Proposed:  
ALTERATIONS to  
YORK HOUSE  
KING STREET  
ROBIN HOODS BAY

Drawing:  
EXISTING  
ELEVATIONS I

Drawing No. 193/12a  
Date: DECEMBER 2017  
Scale: 1/50

S O U T H E L E V A T I O N

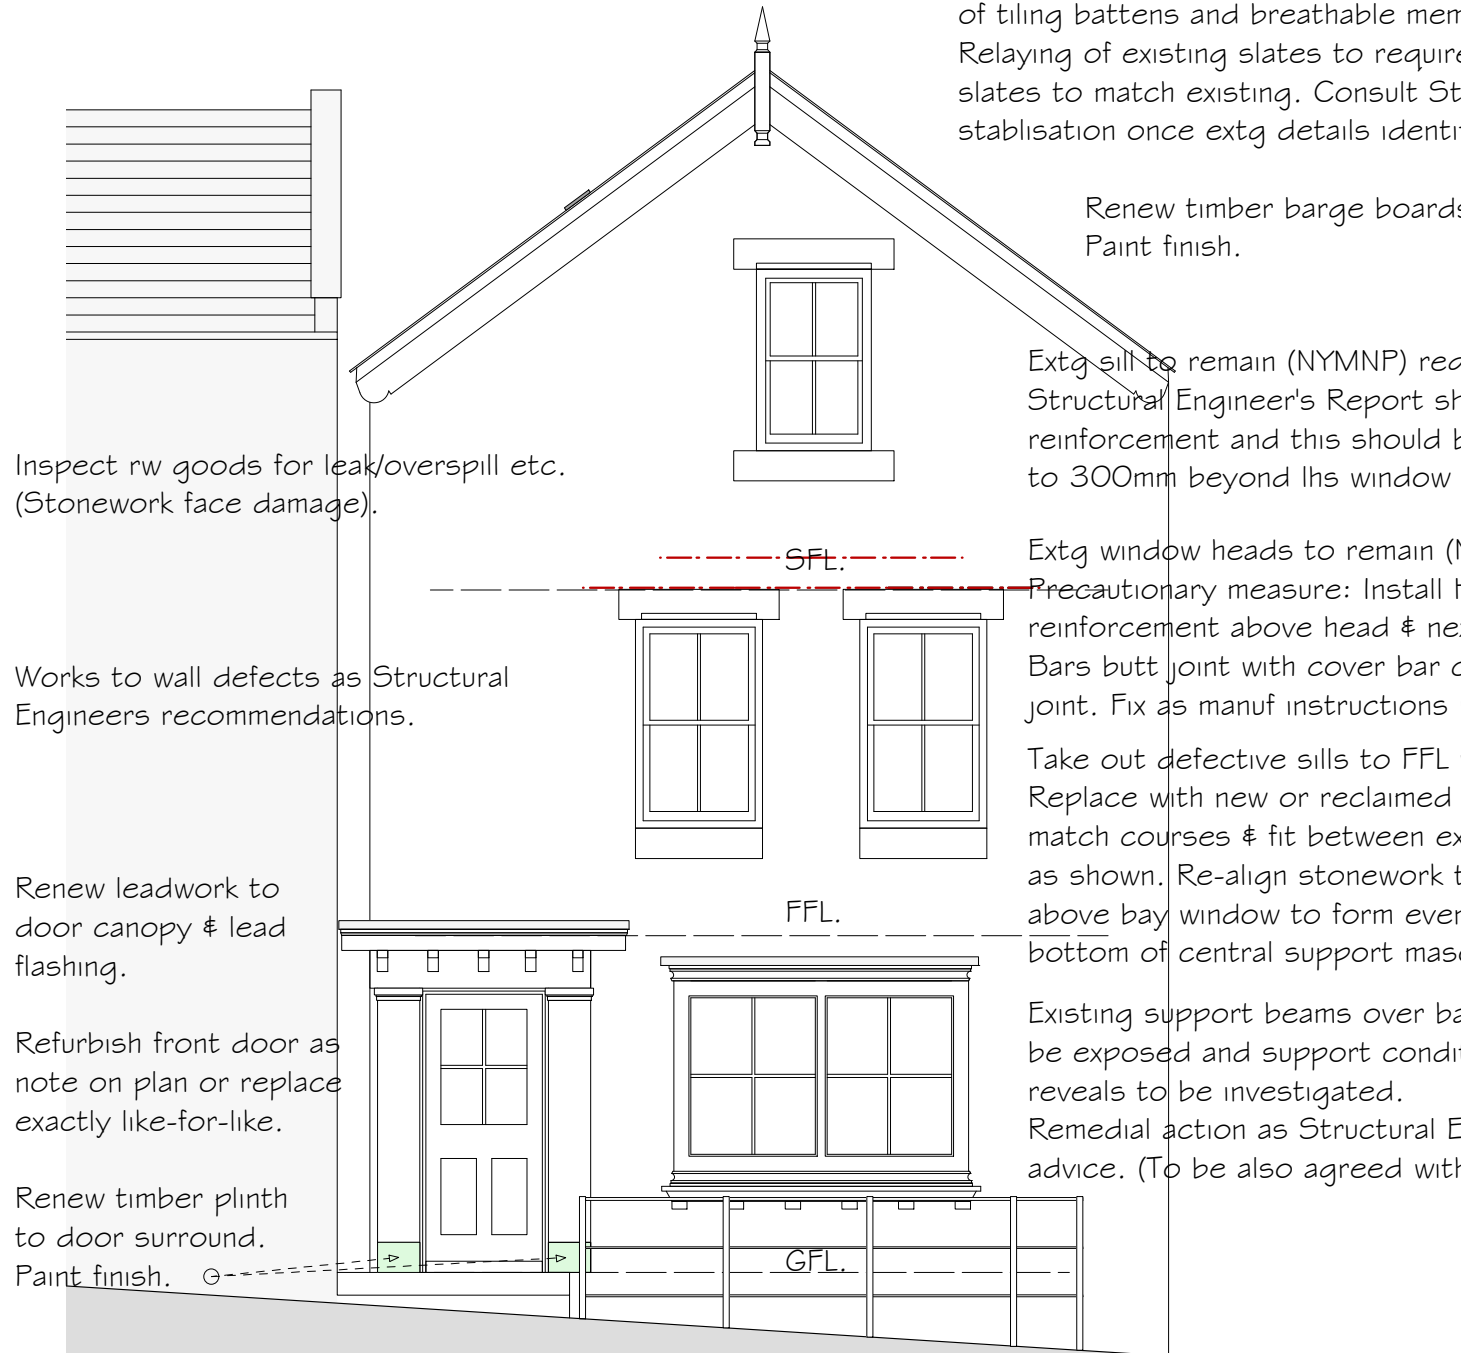
Extractor fan duct from new Shower Room to terminate at proprietary slate vent. Black colour.

Main roof of house to be inspected by specialist roofing contractor. Areas of uneven slating, patching, broken & missing slates, & yawning, give the impression that a complete overhaul may be required. It is anticipated that the slates will require removal and the replacement of tiling battens and breathable membrane underlay will be necessary. Relaying of existing slates to required gauge and lap & any supplementary slates to match existing. Consult Structural Engineer on roof structure stabilisation once extg details identified in engineer's report are known.

Renew timber barge boards & verge timber details. Paint finish.

N O R T H E L E V A T I O N

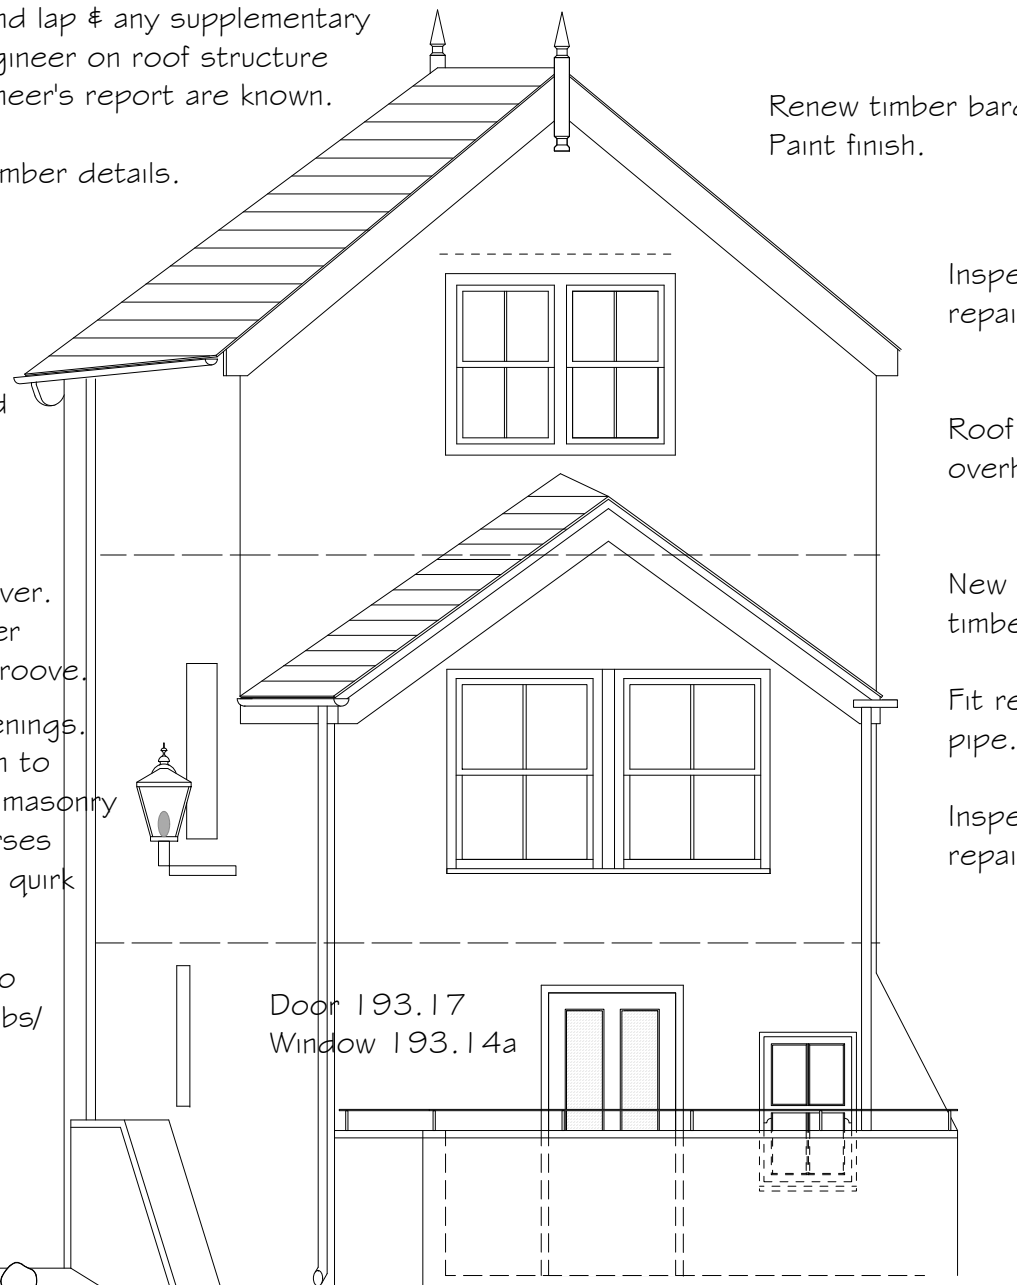
Extg sill to remain (NYMNP) requirement. Structural Engineer's Report shows crack reinforcement and this should be extended to 300mm beyond lhs window opening.

Extg window heads to remain (NYMNP). Precautionary measure: Install Helifix joint reinforcement above head & next course over. Bars butt joint with cover bar centrally over joint. Fix as manuf instructions in 50 mm groove. Take out defective sills to FFL window openings. Replace with new or reclaimed sills section to match courses & fit between extg historic masonry as shown. Re-align stonework to 3no courses above bay window to form even panel incl. quirk bottom of central support masonry.

Existing support beams over bay window to be exposed and support conditions at jambs/ reveals to be investigated. Remedial action as Structural Engineer's advice. (To be also agreed with NYMNP).

Structural:  
Settlement has clearly occurred in the front wall of the building generally emanating from the head of the bay window and rising up the entire facade. There is evidence that work has been carried out in the past however there are obvious problems which remain to be addressed. Refer to Structural Engineer's report.

Inspect timber to window frame & repair as required. Paint finish.

Roof to first floor extension to be overhauled as notes on plan drawing.

New timber barge boards & verge timber details. Paint finish.

Fit return to rw gutter & 50mm fall pipe. Discharge to current location.

Inspect timber to window frame & repair as necessary. Paint finish.
